Office Action Summary

10/731,705

WOJCIK ET AL.

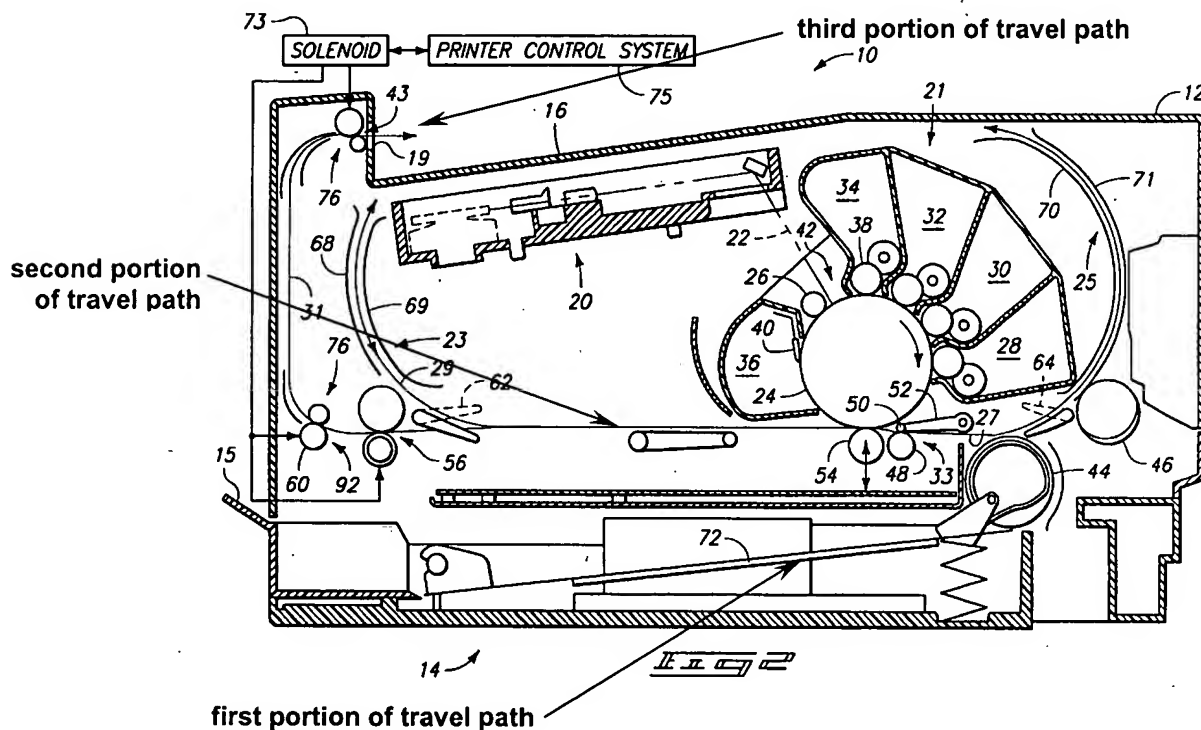
With respect to claim 7, Goldberg et al. discloses the claimed system for printing except for the second portion of travel. However, Guerrero et al. discloses a printing system that includes a first portion and an overlapping second portion of the travel path as shown below in the Figure taken from Figure 2 of Guerrero et al.:

With respect to claim 8, Guerrero et al. teaches a third portion as shown in the above Figure taken from Figure 2 of Guerrero et al. The third portion overlaps a portion of the second portion.

With respect to claim 9, Guerrero et al. teaches a first and second portion of the recording element travel path such that the directions of the travel paths are opposite of one another as shown above.

With respect to claim 10, Guerrero et al. teaches a third portion of the travel path having a third direction of travel that is substantially similar to the first direction of travel as shown above.
